# CITY OF ALBUQUERQUE

**Re: Take 5 Oil Change**  
**1125 Snow Vista Blvd. NW**  
**Traffic Circulation Layout**  
Engineer's Stamp 11-03-23 (M09-D012C)

# TAKE 5 OIL CHANGE - ALBUQUERQUE, NM

## SITE PLAN

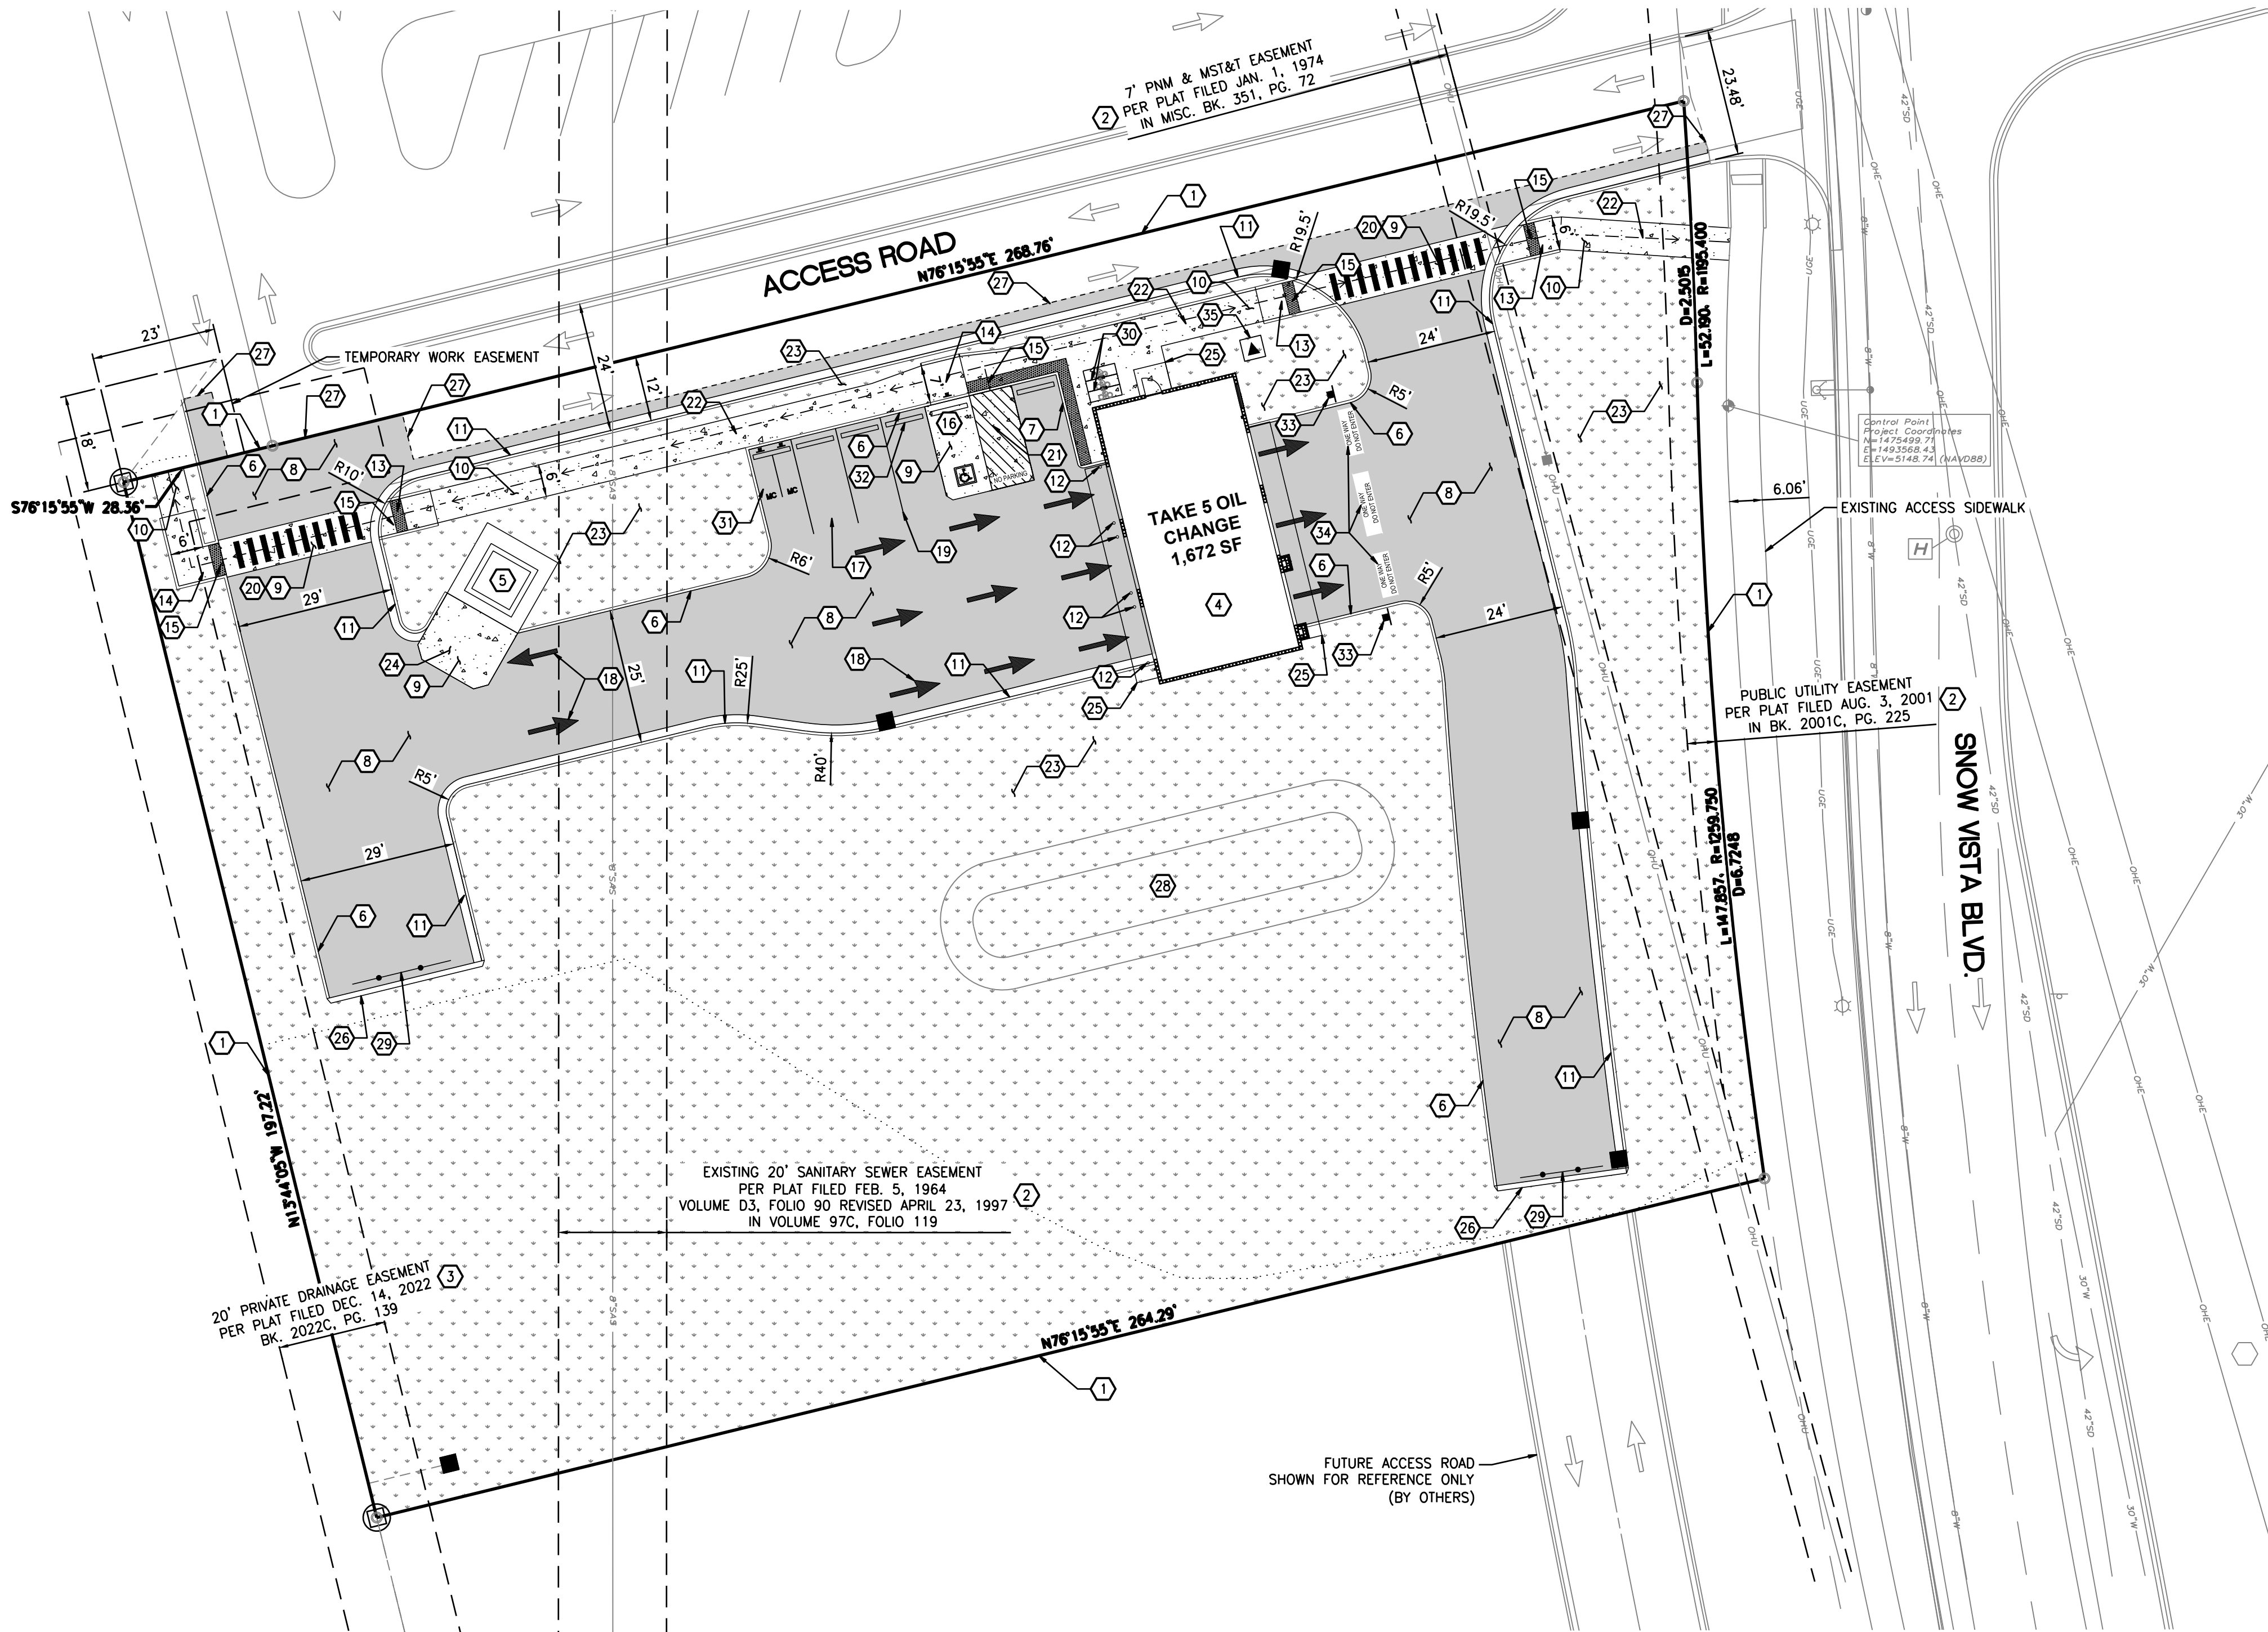
When the site construction is completed and an inspection for Certificate of Occupancy (C.O.) is requested, use the original City stamped approved TCL for certification. Redline any minor changes and adjustments that were made in the field. A NM registered architect or engineer must stamp, sign, and date the certification TCL along with indicating that the development was built in "substantial compliance" with the TCL. Submit this certification, the TCL, and a completed Drainage and Transportation Information Sheet to the [PLNDRS@cabq.gov](mailto:PLNDRS@cabq.gov) for log in and evaluation by Transportation. **A 24 FT. WIDE ACCESS ROAD AT THE NORTH SIDE OF THE SITE, MUST BE BUILT PRIOR TO ISSUE A FINAL CO.**

A 24 FT. WIDE ACCESS ROAD AT THE NORTH SIDE OF THE SITE, MUST BE BUILT PRIOR TO ISSUE A FINAL CO.
